Subject: Phase 4 Open Items - Punching Shear  
Texas Utilities Generating Company  
Comanche Peak Steam Electric Station  
Independent Assessment Program - Phase 4  
Job No. 84056

Subject: Phase 3 - Walsh Doyle Allegations  
Richmond Insert Allowables and Bending Stresses  
Texas Utilities Generating Company  
Comanche Peak Steam Electric Station  
Independent Assessment Program  
Job No. 84042

Subject: Phase 3 Open Items  
Mass Participation and Mass Point Spacing  
Comanche Peak Steam Electric Station  
Independent Assessment Program  
Job No. 84042

Subject: Cable Tray Support Review Questions  
Comanche Peak Steam Electric Station  
Independent Assessment Program - Phase 4  
Job No. 84056

FIGURE 1 WELD BETWEEN CONNECTION ANGLE AND TRAY HANGER

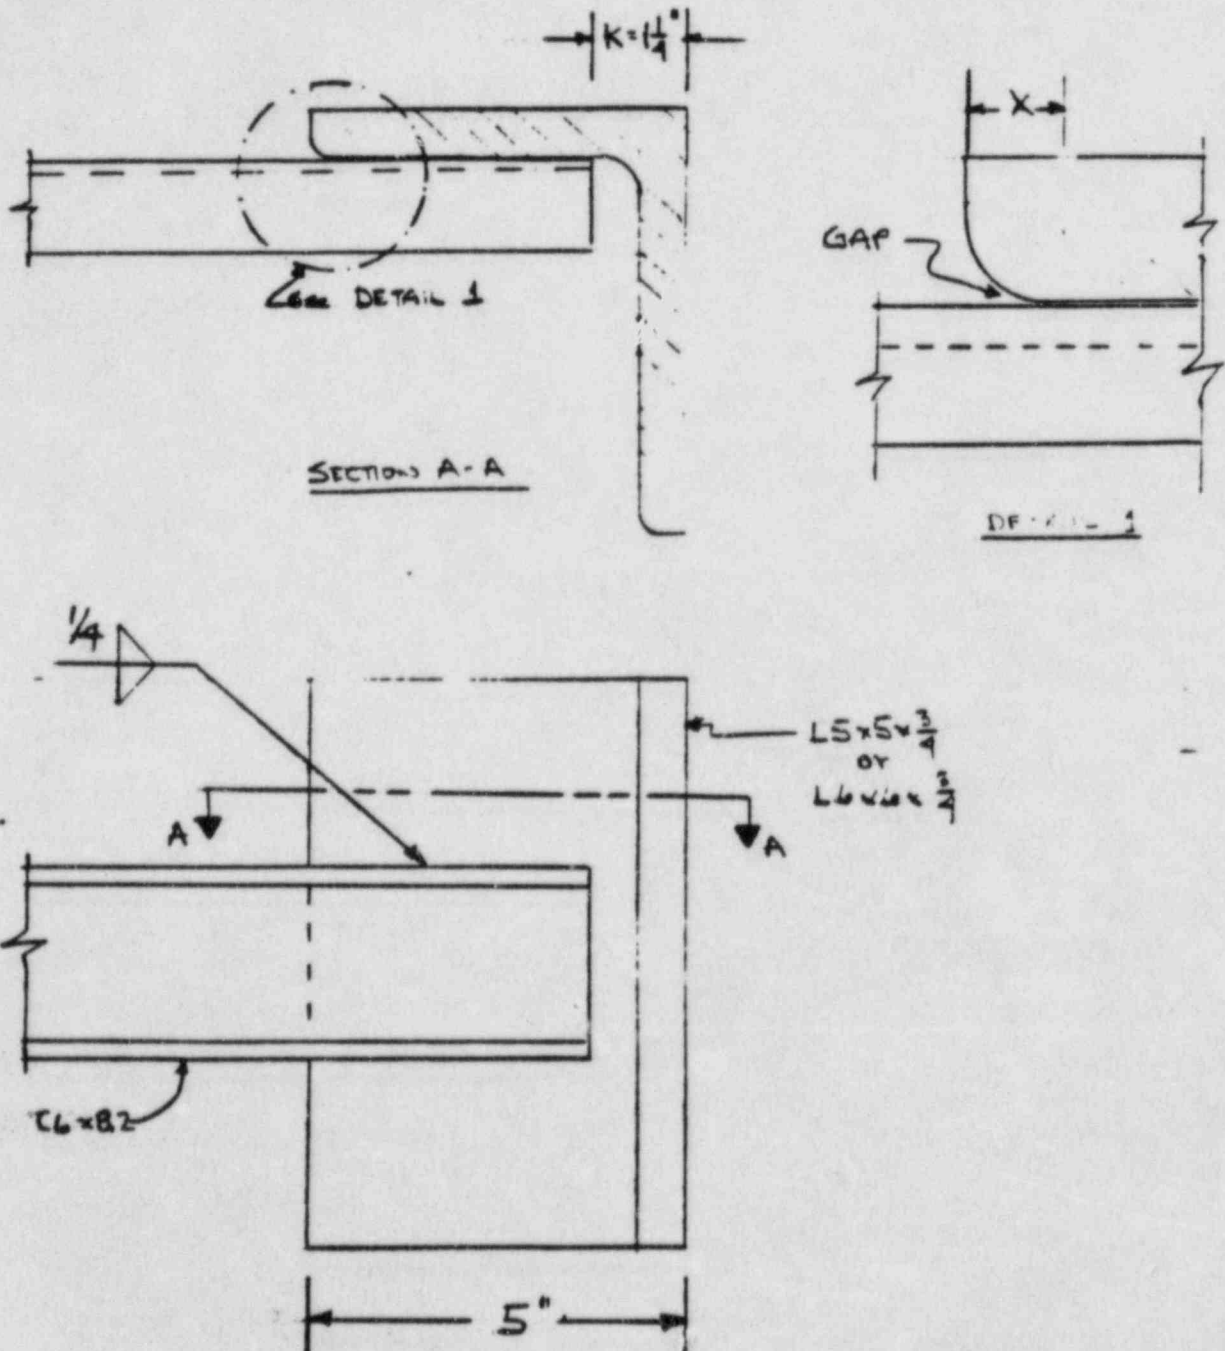
Further review by Cygna noted that due to the radius at the toe of an angle section, a gap will exist between the web of a channel and the angle section at the toe. (See Figure 1.) In order to achieve a  $3-3/4"$  weld length and the necessary return, the fillet weld must bridge this gap. Cygna believes that without the use of a special welding procedure, a fillet weld will not achieve its full effective throat at this location, and thus the weld section properties will be less than considered in the design calculations.

- The installation tolerance for the connecting weld length that was used prior to the issuance of CMC 82988 and provide assurance that a minimum weld length of 3-3/4" was always provided.
- The welding procedure which applies to performing a fillet weld over the gap between the channel and the toe of the angle section or documentation to show the acceptability of the connection.
